SCHEMATIC TITLE
SN65TMD5361 EVM

PAGE TITLE
High Speed RX/TX
<Page Title 2>

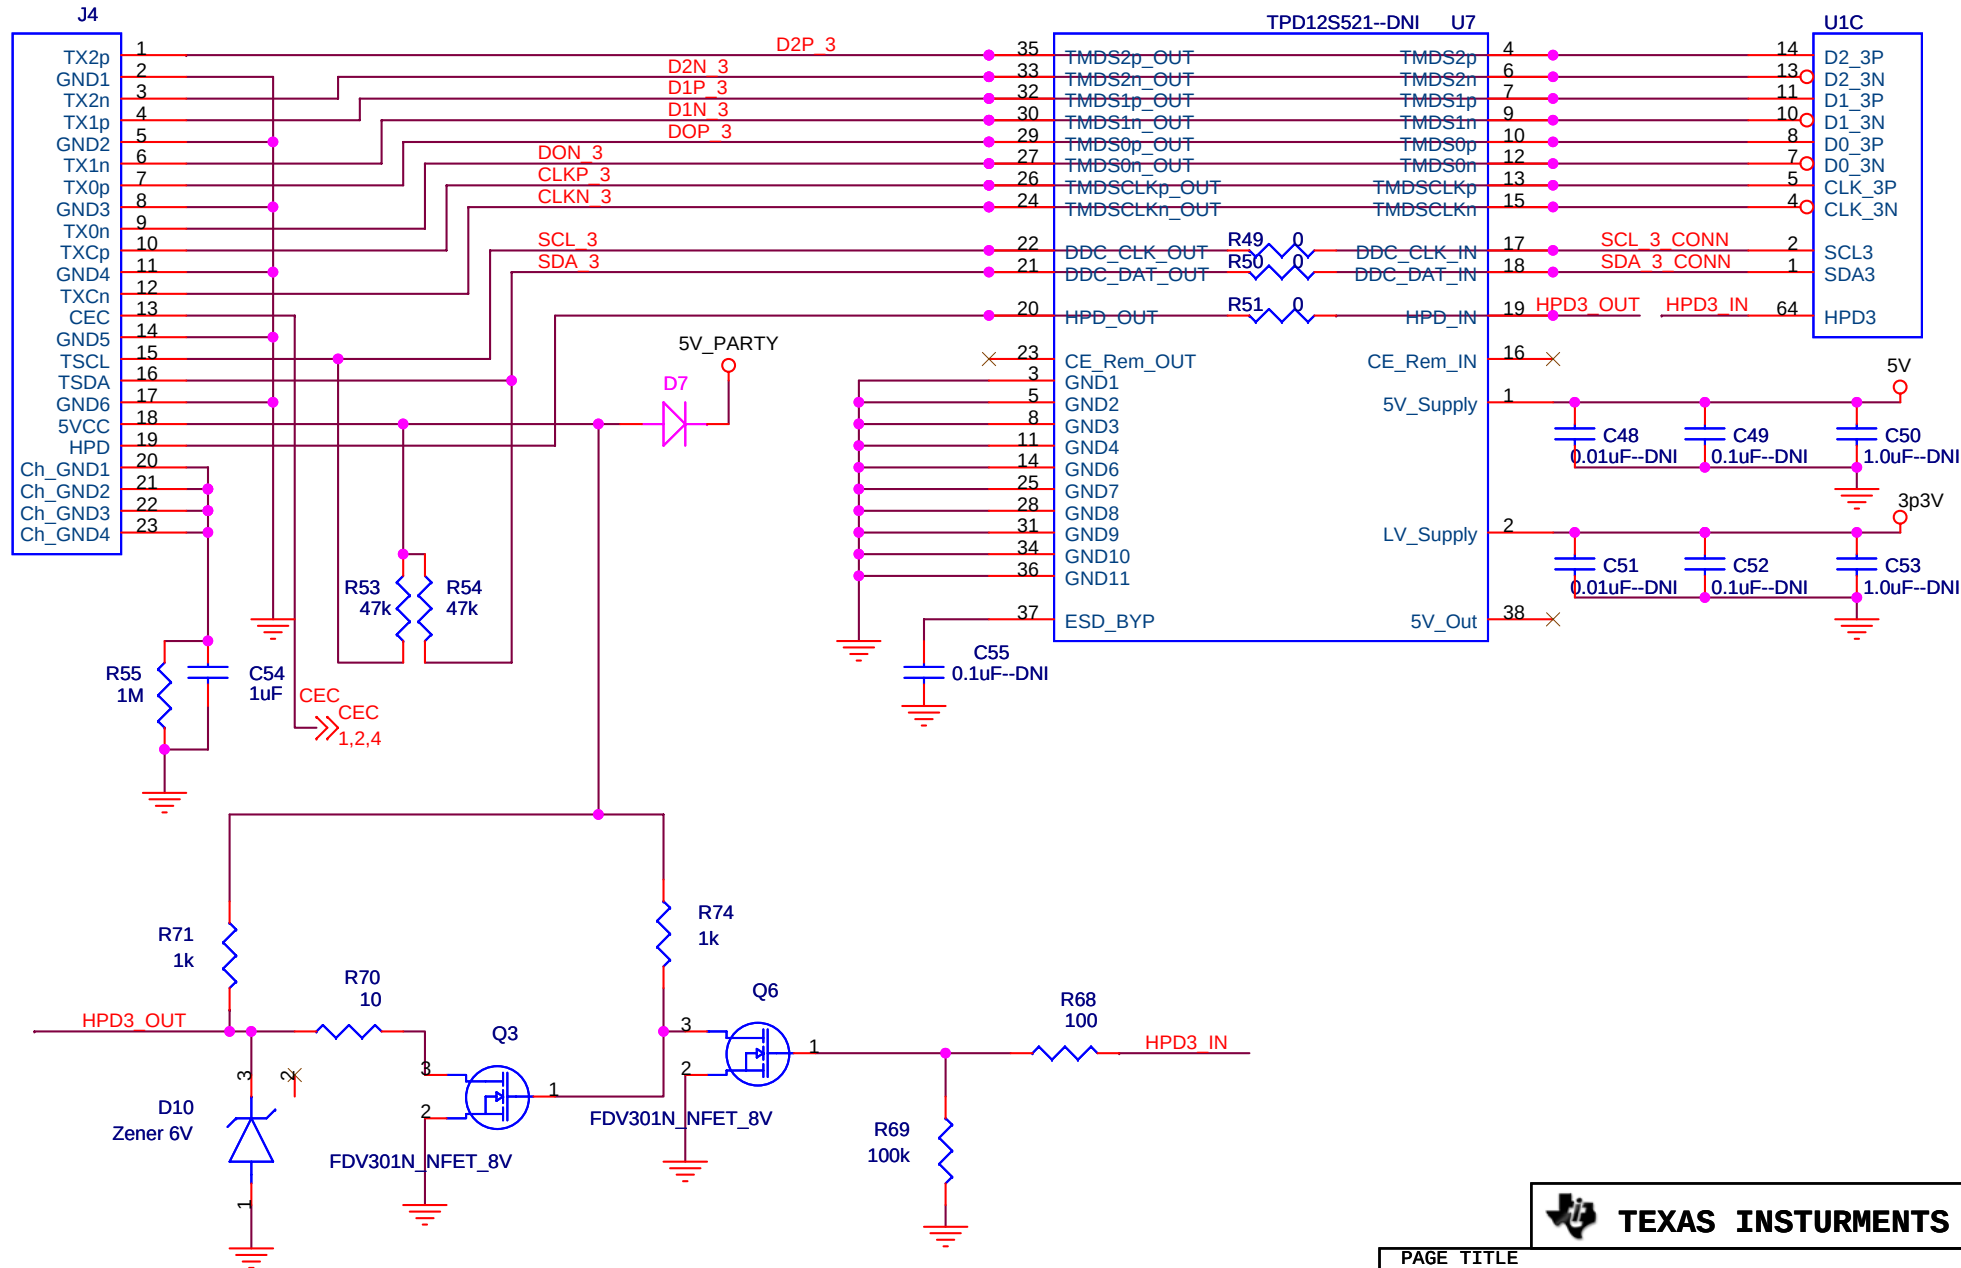
R16: 4.7k for TMD361 and 0 for TMD351

This should 5V and not 3p3V

PAGE TITLE Control			
SIZE A	DOCUMENT NUMBER <Document Number>	REV A	PAGE 5 of 7

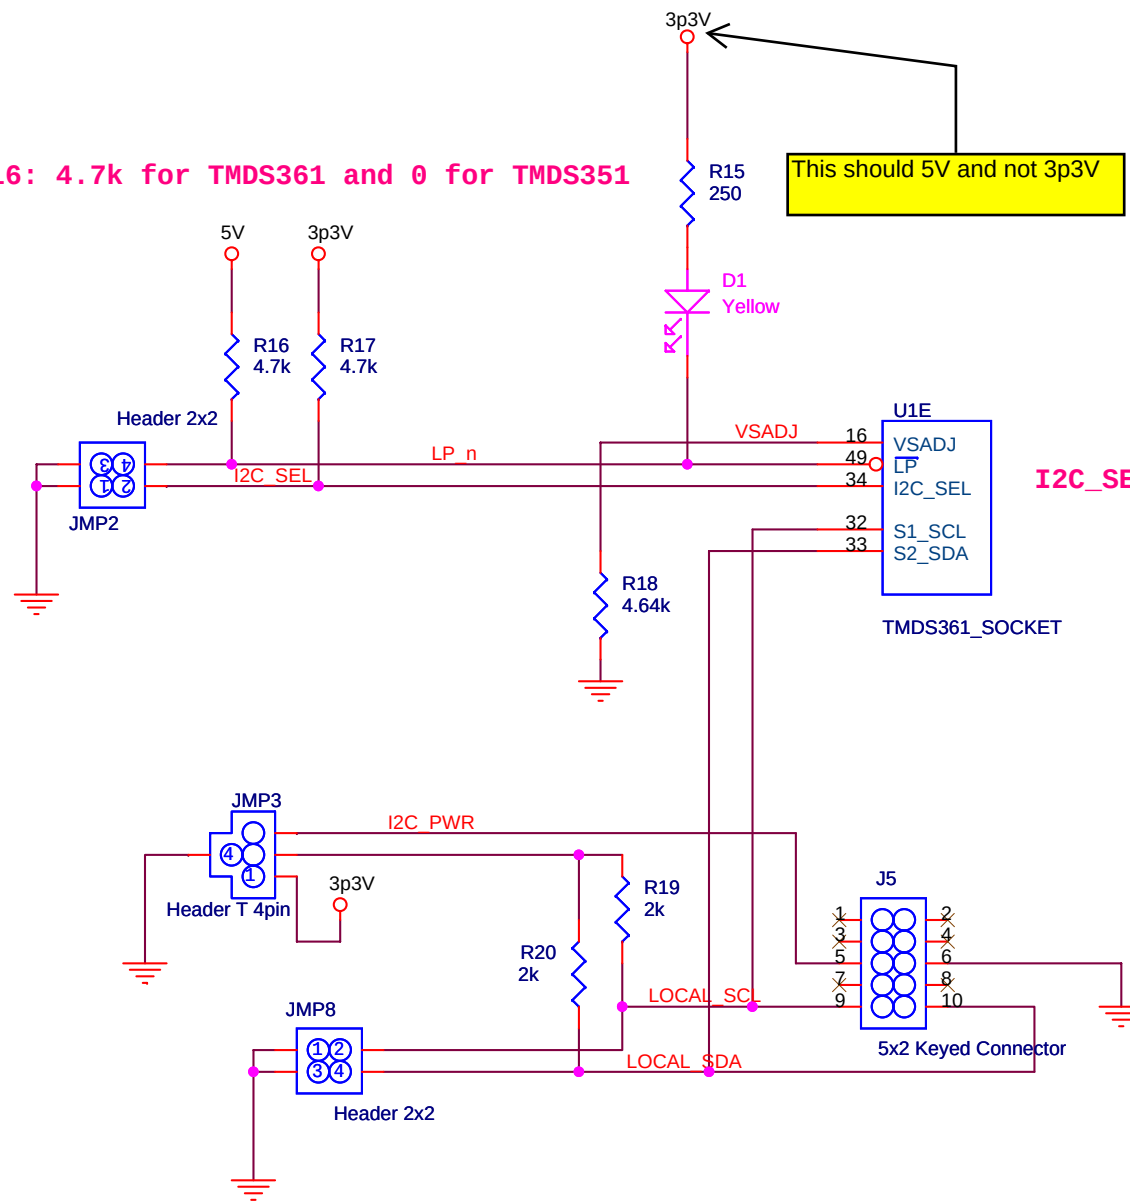
I2C_SEL for TMD351 is EQ

PAGE TITLE 5V Power			
SIZE A	DOCUMENT NUMBER 6502334	REV A	PAGE 6 of 7

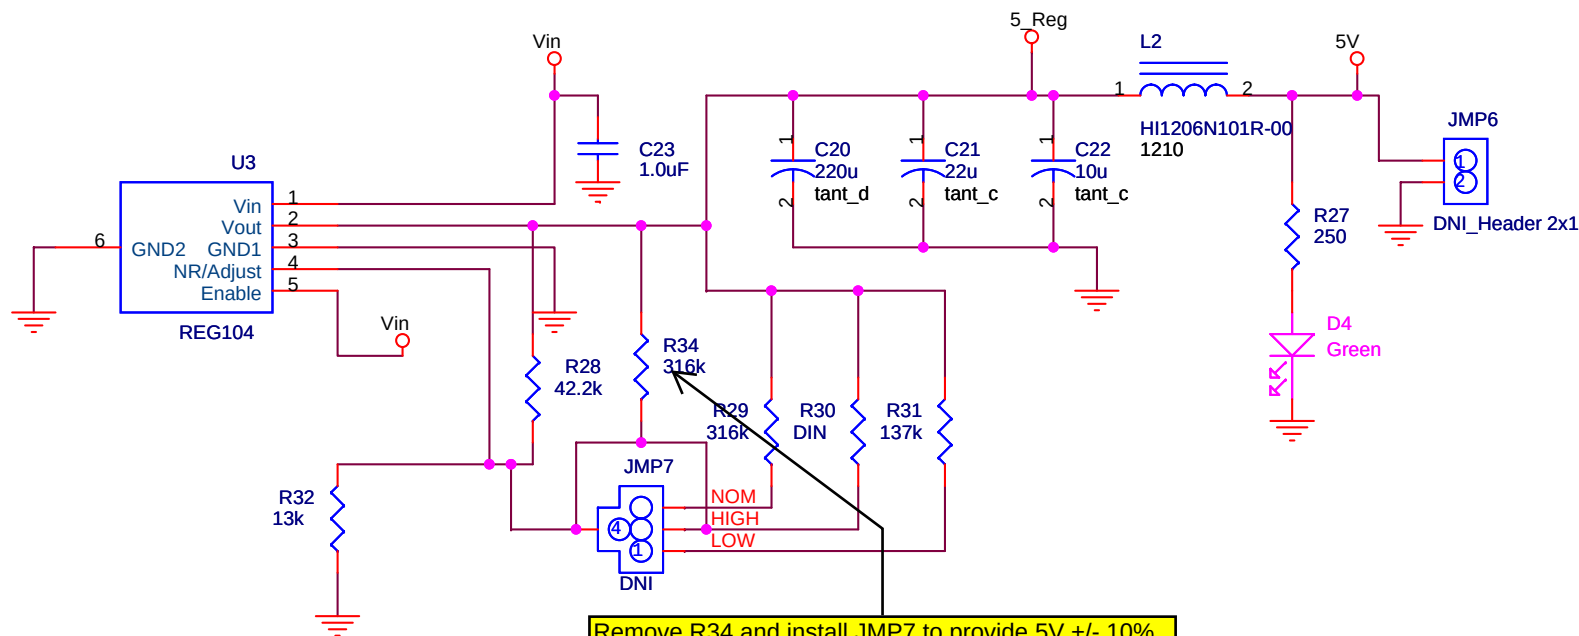
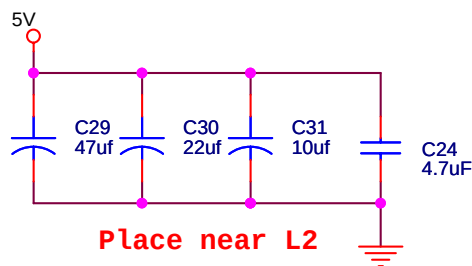
Remove R34 and install JUMP7 to provide 5V +/- 10%
